This kit contains a new style one-piece drain solenoid and replaces the older two piece versions. (Fig 1)

Fig. 2

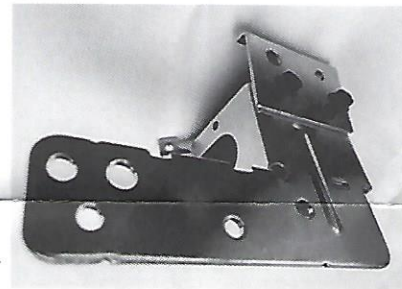
Note - On models with Electronic Drain Feedback Switch (EESF) the included adapter bracket must be installed. Install the extra mounting bracket with self tapping screws as shown on Fig 2. Attached the EESF to the adapter bracket using original screws.

Do not use this bracket on all other models.
